NON-COMPLIANCE NOTICE (NCN)

Owner:	City of Oklahoma City / Oklahoma City Water Utilities Trust	Date Issued:	04/29/2021
Contractor:	Archer Western Construction	Carollo Project No.:	10949A.30
Project Name:	WT-0159 Draper Water Treatment Plant, Various Improvements to Strengthen the Redundancy and Resiliency for Water Treatment and Storage	Notice No.:	002
Subject/Item:	120-Inch Pipe Installation (Floatation)	Spec/Dwg. Reference:	02312/ 02708

Owner:	City of Oklahoma City / Oklahoma City Water Utilities Trust	Date Issued:	12/27/2022
Contractor:	Archer Western Construction	Carollo Project No.:	10949A.30
Project Name:	WT-0159 Draper Water Treatment Plant, Various Improvements to Strengthen the Redundancy and Resiliency for Water Treatment and Storage	Notice No.:	004
Subject/Item:	Ammoniators, PRV's, Vacuum Regulating Valve Non-compliance	Spec/Dwg. Reference:	11261/P&ID's

SUBMITTAL NAME: Capital Controls Series 4100B Ammonia Feed Cabinets- Substitution request
pending

VACUUM REGULATOR — DIMENSIONS & CONNECTIONS

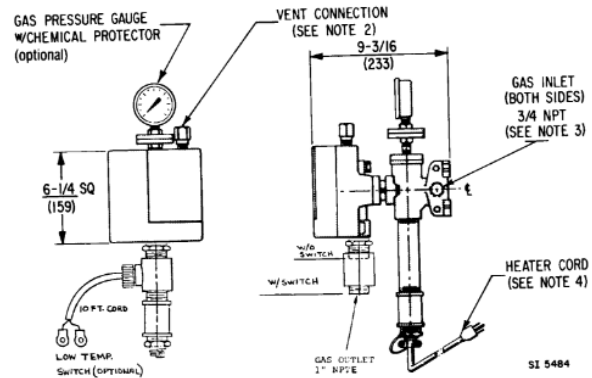
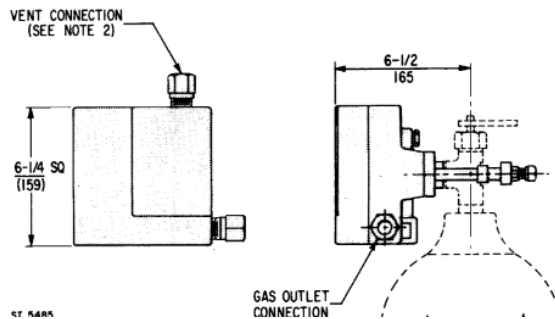
5. Please provide a statement verifying compatibility with the previously provided vacuum regulating valves and PRV. It appears that the vacuum regulator associated with this cabinet is different than that provided originally, please provide compatibility statements as part of the substitution request:

Automatic Control Module

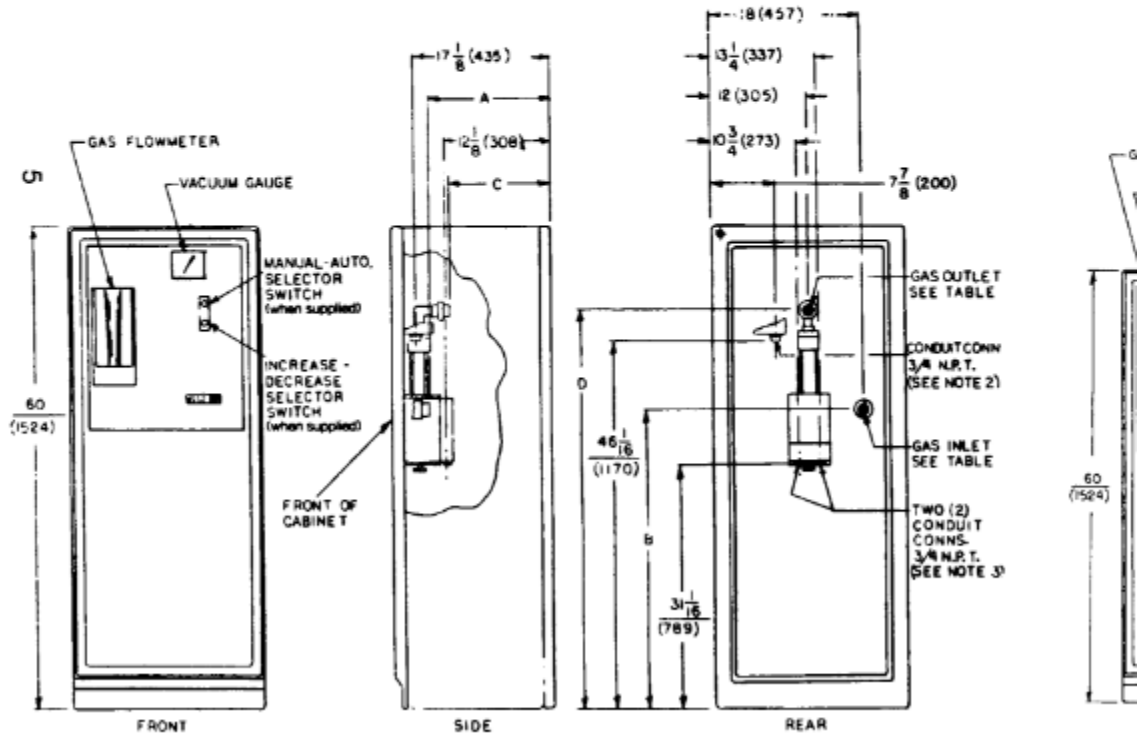
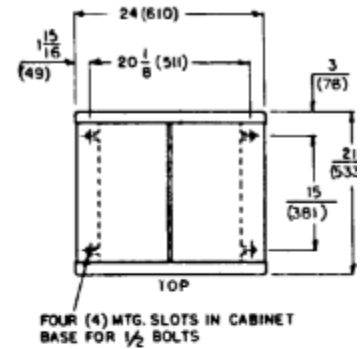
13. Please verify selection of model as series 4140B. We want the ability to control these remotely. We do not need the controller as we will not be controlling on ammonia residual just a dose ratio in the scada with free ammonia feedback for adjustment of the signal to the ammoniator from the pLC. However, we do want the feedback on the ammoniator flow setting back to scada. It seems that the literature was not very clear on whether this was available in the unit, please provide additional clarification/information.

14. Please verify for the flow tube what the 8330 designation is. We read that the top feed rate is 975 ppd or is the top feed rate 1000 ppd. It makes a difference regarding the redundancy/number of on-line units.

**AMMONIATOR ROOM
SECTIONS**

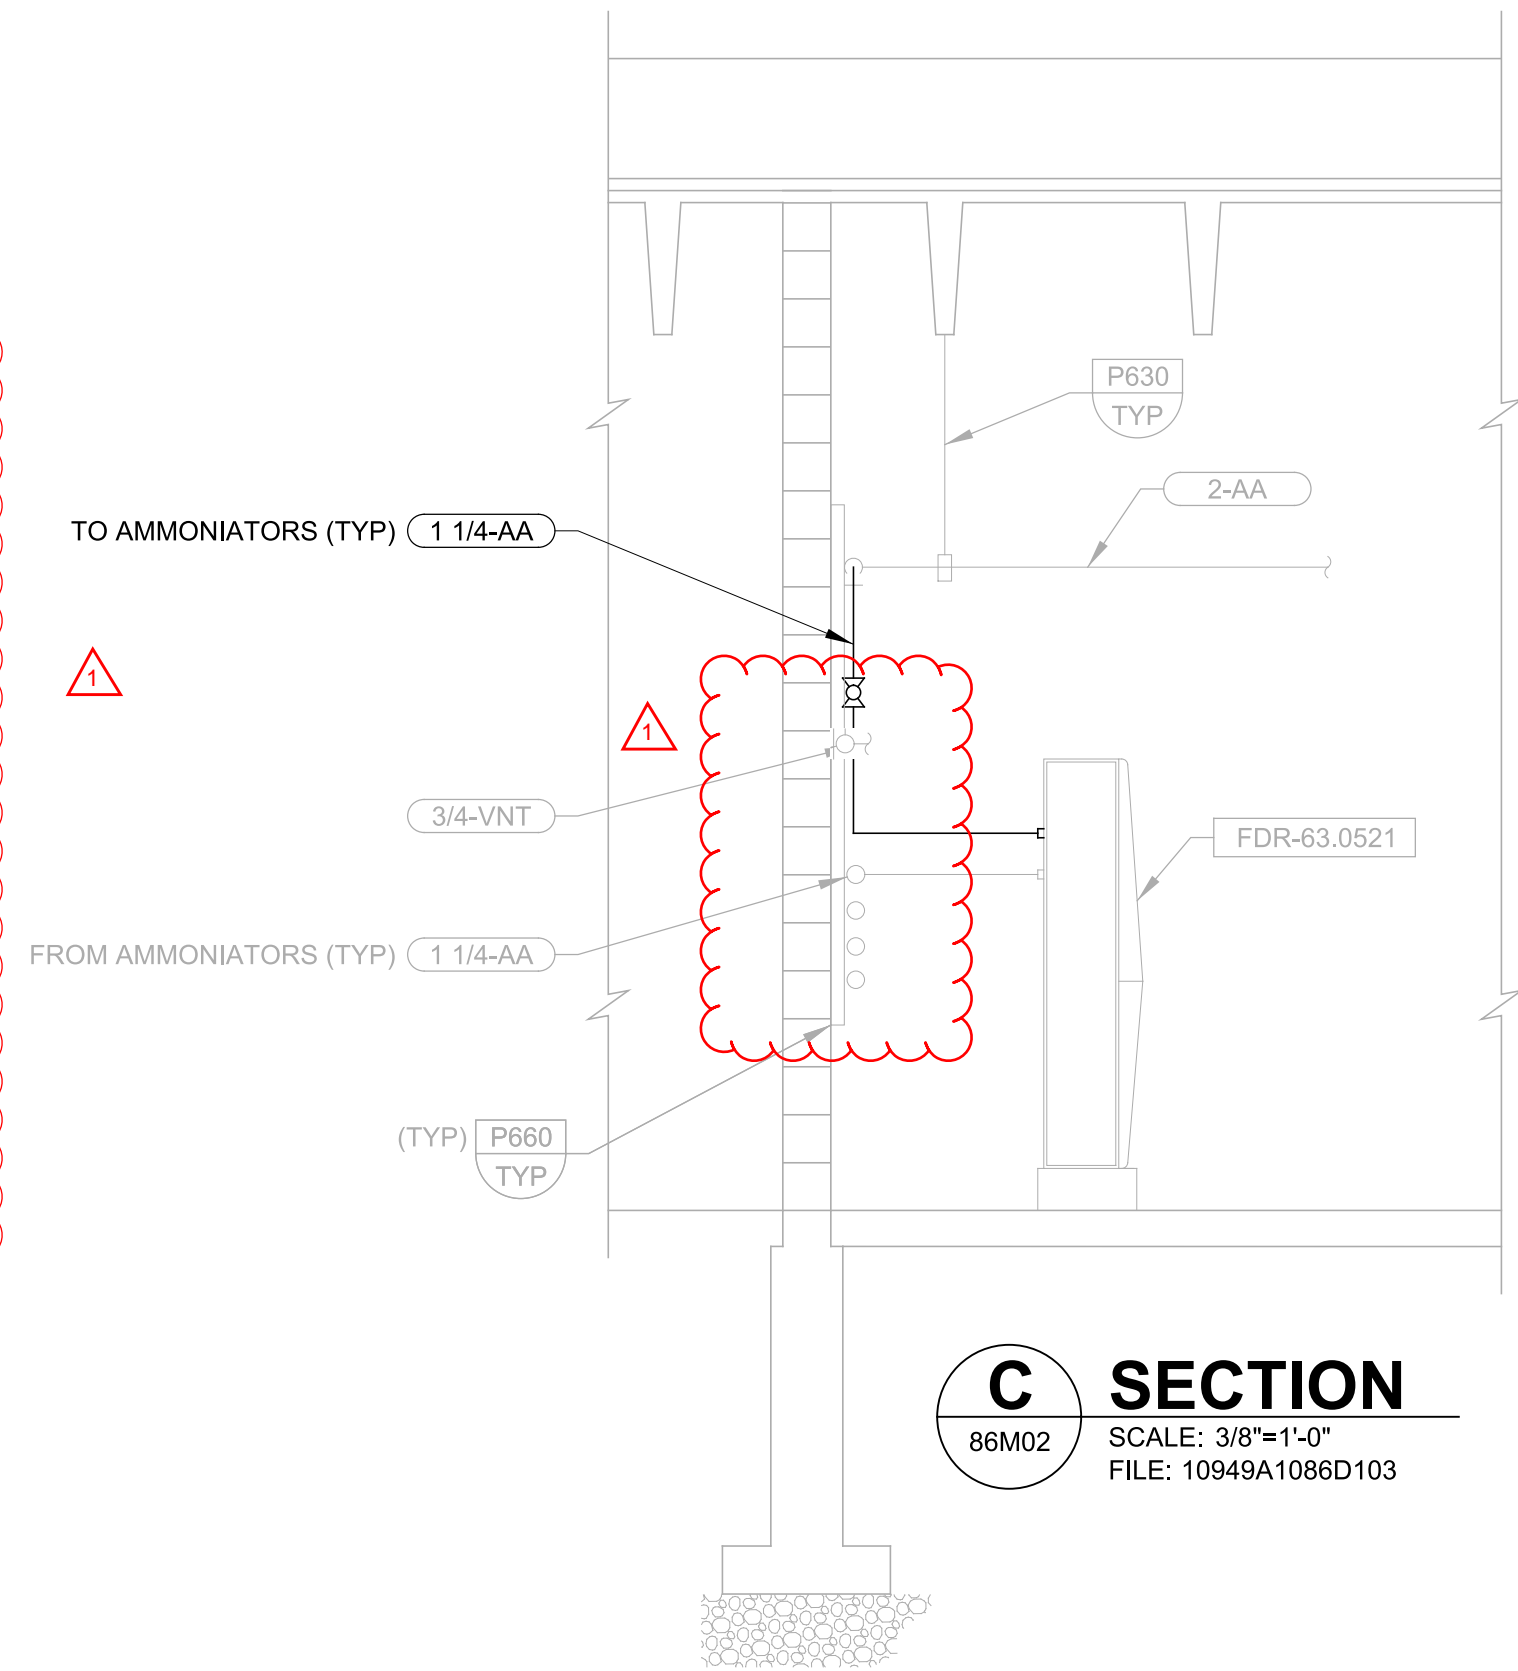
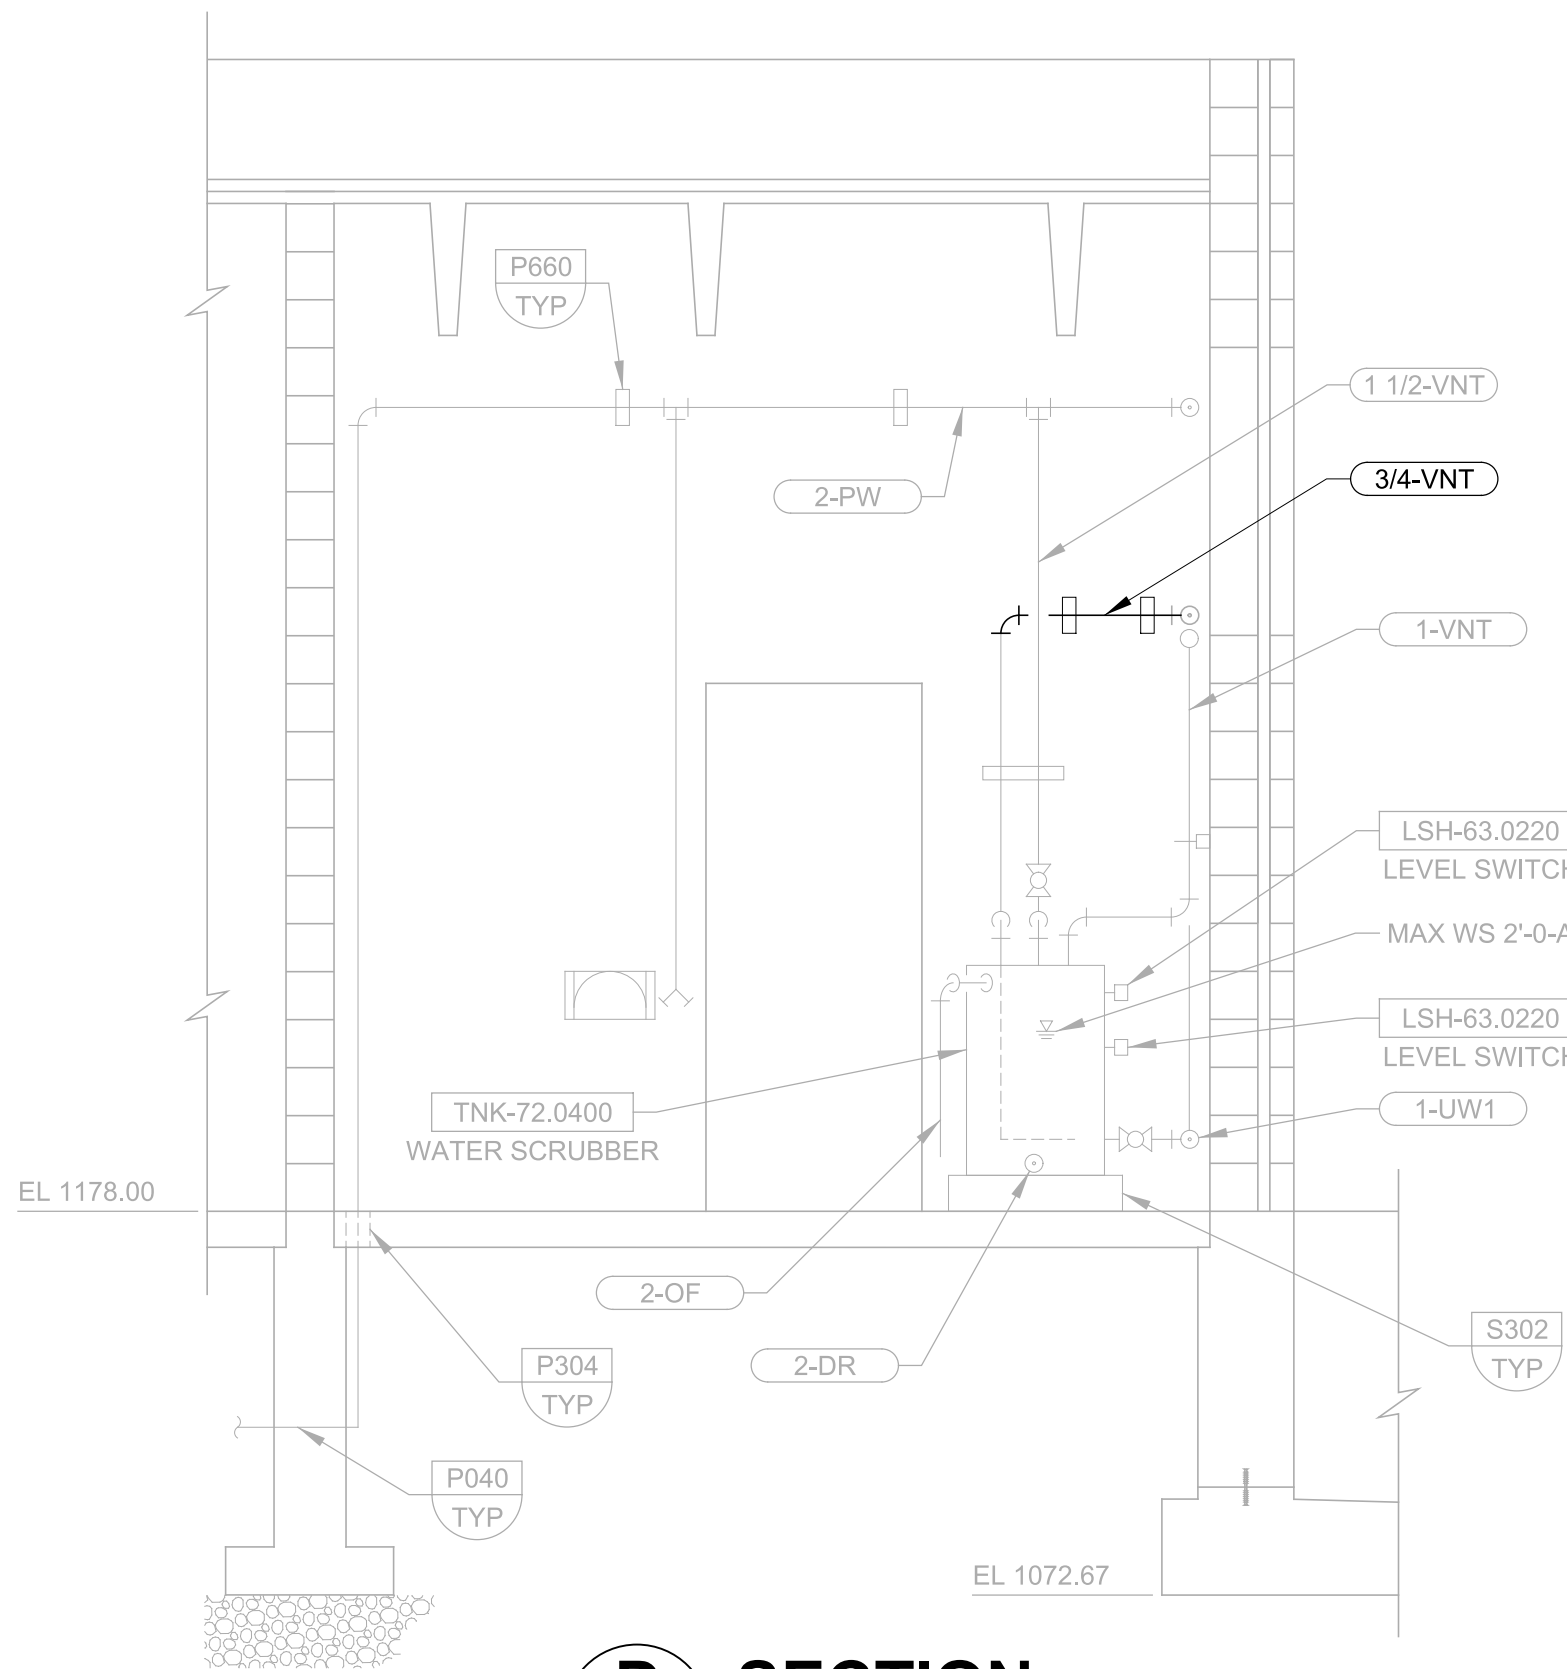
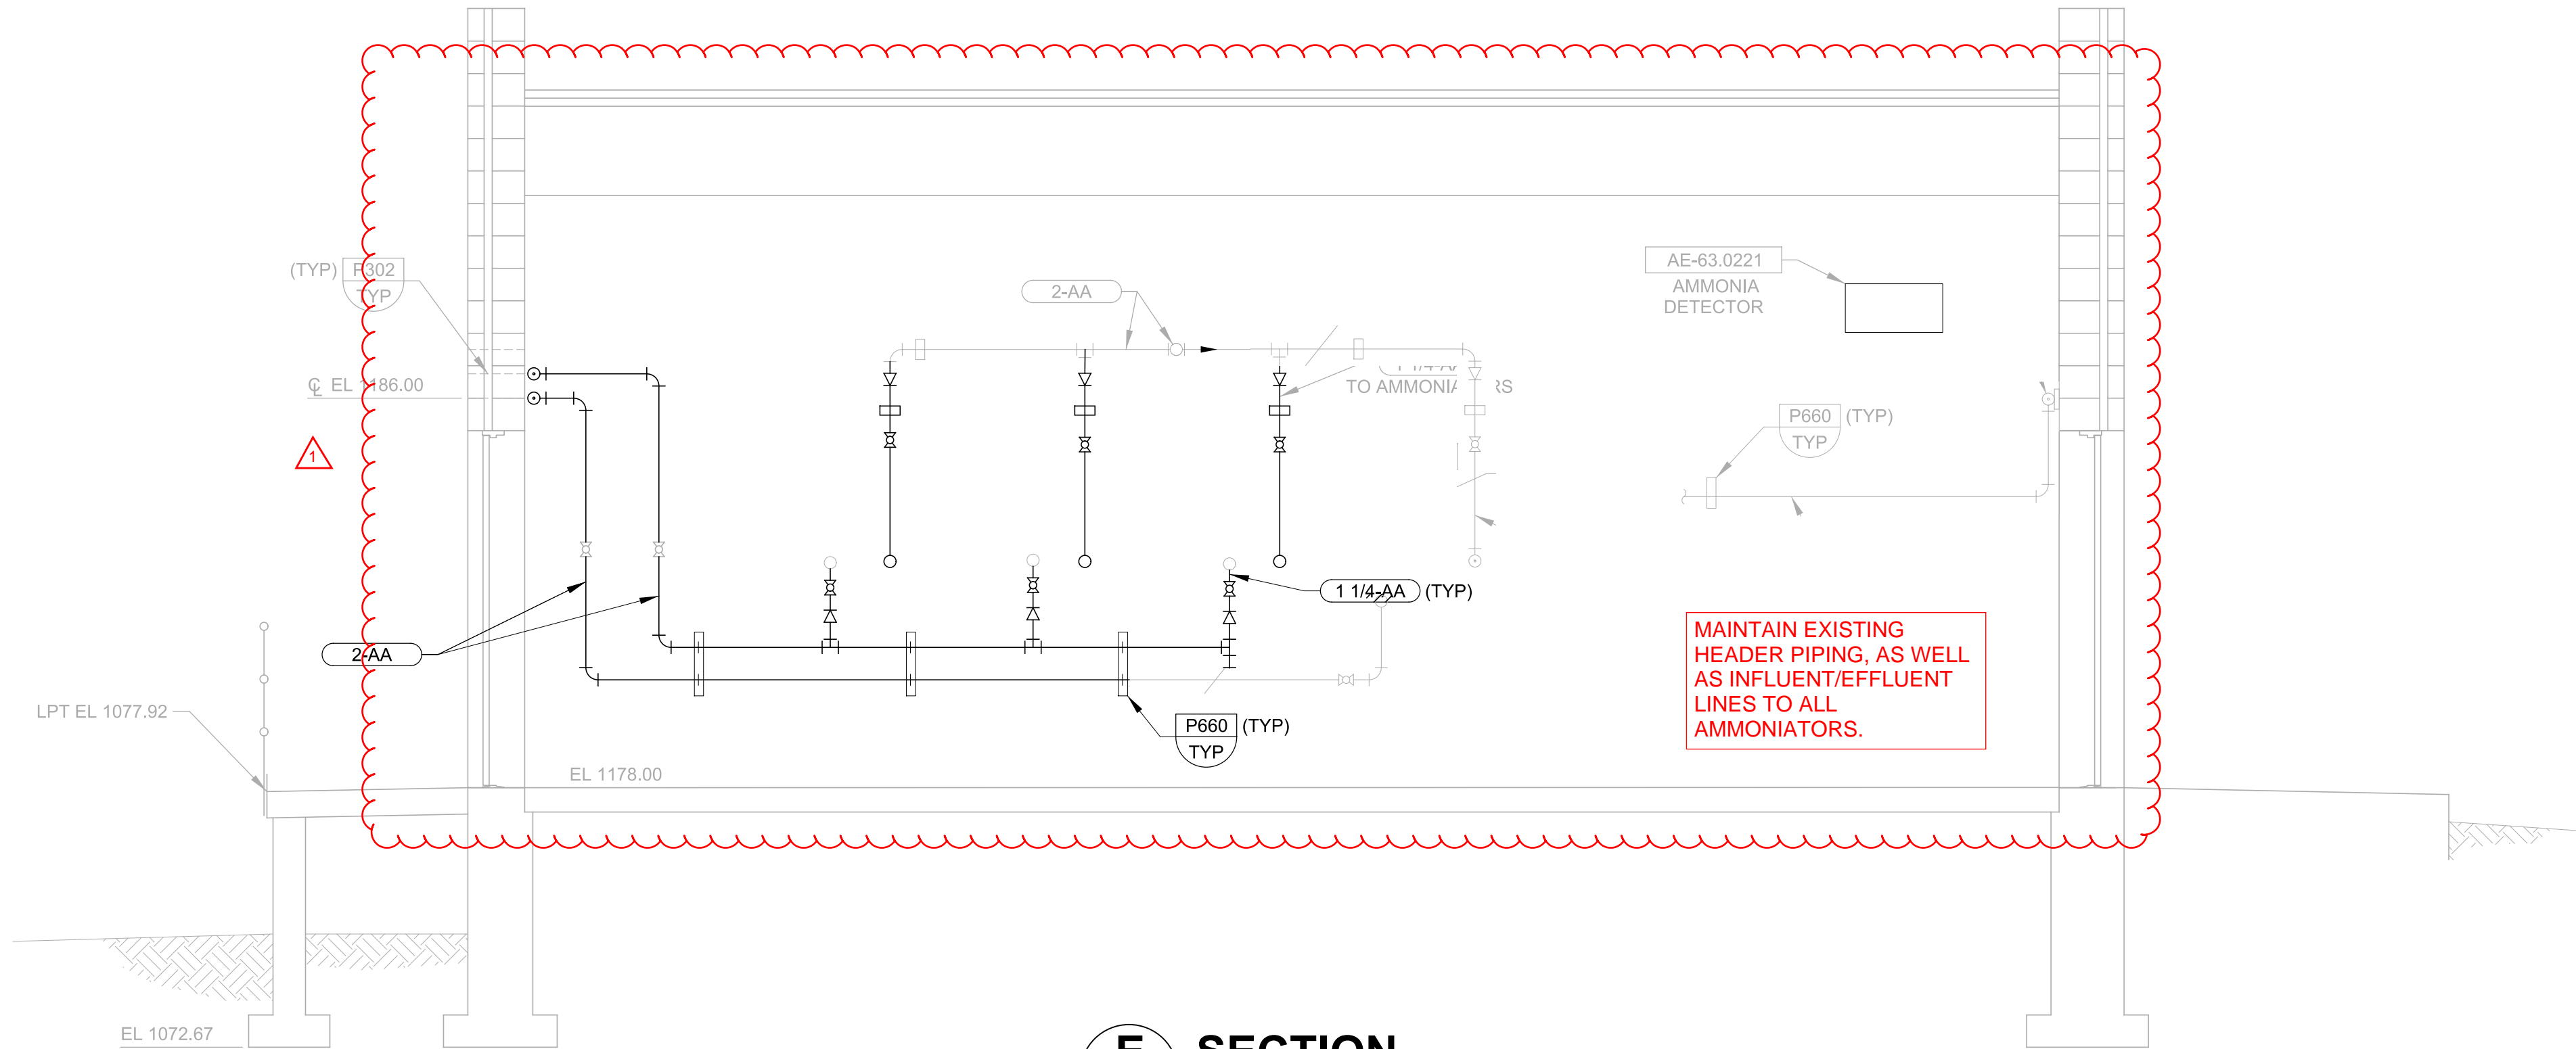
12. Please field verify that ammoniators will fit in the existing space (see attachment C) and include in substitution requests.

MEMO

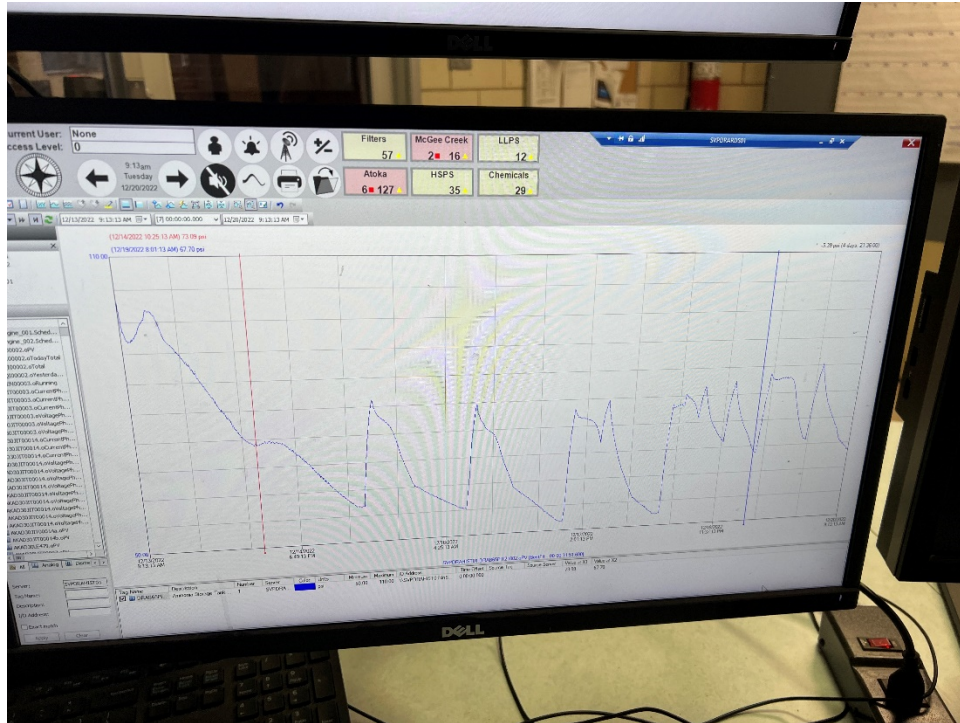
It was discovered that the ammonia line between the PRV valve on the gas feed line, through the vacuum regulator check unit, to the PVC feed line was freezing up.

There was visible frosting on the lines and it appeared to have liquid in the lines. Touching the lines you could feel what seemed like liquid ammonia bubbling in the lines at the drip leg at the Vacuum regulator and the PVC feed line immediately after.

We then noticed liquid ammonia coming from the PVC nipple between the vacuum regulator check unit and the first ball valve. We left the room opened the doors.

The Ammonia tank heater was warm to the touch, The line pressure seemed normal, The heater in the feed room was functioning correctly,

There was no frost on the feed line prior to the PRV valve. The feed line was warmer prior to PRV valve on the gas supply line than after the PRV.

ENGINEER's RESPONSE: Based upon a walkthrough with the draper staff and discussions on the operations of the ammonia tank:

- d. It appears that liquid ammonia appears DOWNSTREAM of the installed ammonia PRV (installed on the project) as evidenced by the freezing of these pipes from downstream of the PRV.

- e. Liquid ammonia in the vacuum regulating check valve is the likely cause of the “bobbing” feeder.
- 5) When the ammonia was placed back to the direct feed ammoniator and the EXISTING PRV, there seemed to be no issues with the system.

Given this, we have asked Archer Western to discuss this with Denora to determine:

- 1) Is the PRV installed in the correct manner (vertical vs horizontal)? There seems to be some question as to whether the Horizontal installation is recommended rather than the vertical installation but the literature is not clear.

- 2) Is the PRV the correct application for this installation? Recall that the original specified PRV's were automatic rather than manual and these were replaced and sized by Denora as a replacement to the originally specified valves.

- 3) Is the PRV the correct size for the application? The piping feeding and leaving the PRV is much larger (1.5") than the PRV $\frac{3}{4}$ ". The existing PRV is 1.5".
